## Cardinia Planning Scheme - Amendment C238

### Am C238 Submissions

Fifteen submissions have been received in relation to Amendment C238. The submissions have been consolidated into this one document.

Figure 14. Location of Proposed DCP Items (Development Contributions Plan (Draft) June 2020, Urban Enterprise & Cardinia Shire Council)

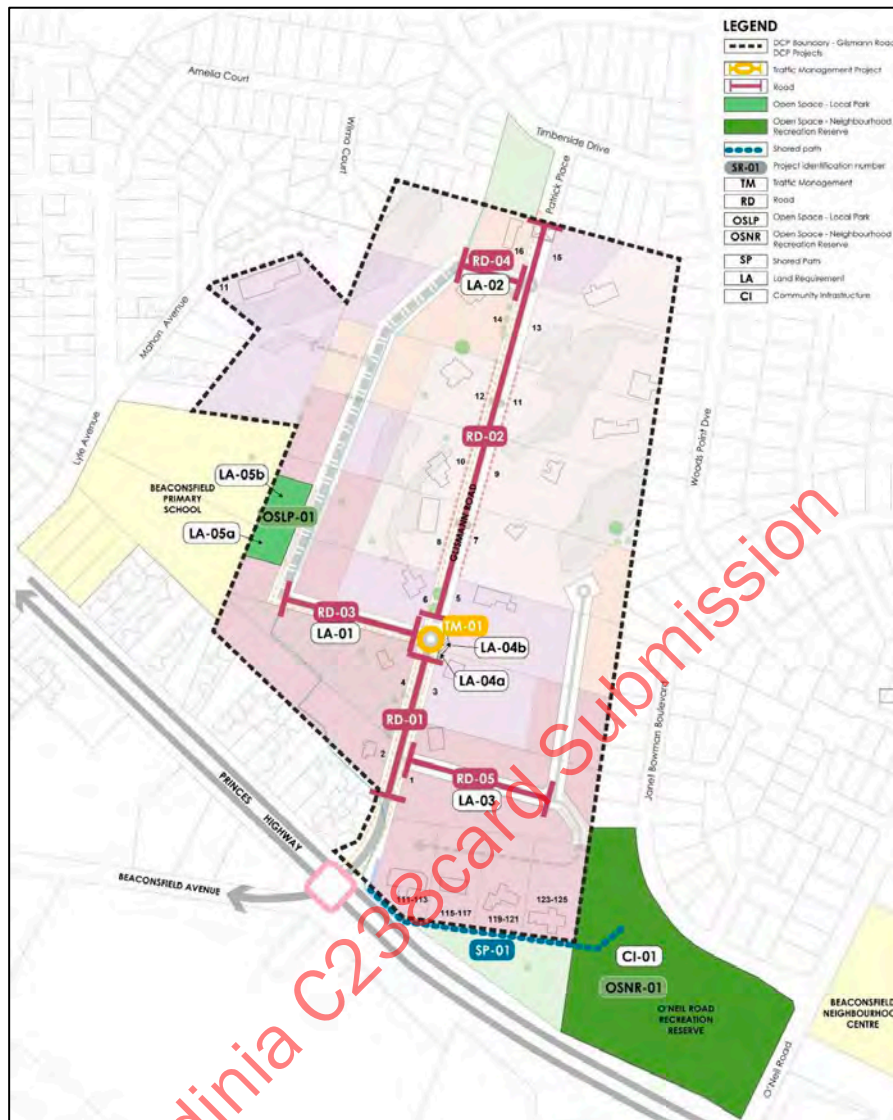
The important outcome of the above assessment is that although portrayed as only a minor road connection on the proposed Development Plan, it would not be minor at all. It would in fact require a massive amount of earthworks and take up considerable developable area, at a great cost to the land owners. The cost would be borne by the landowners of the subject site [REDACTED] as this infrastructure item has been excluded from the proposed DCP. A copy of the DCP Item Plan is included at Figure 14, overleaf.
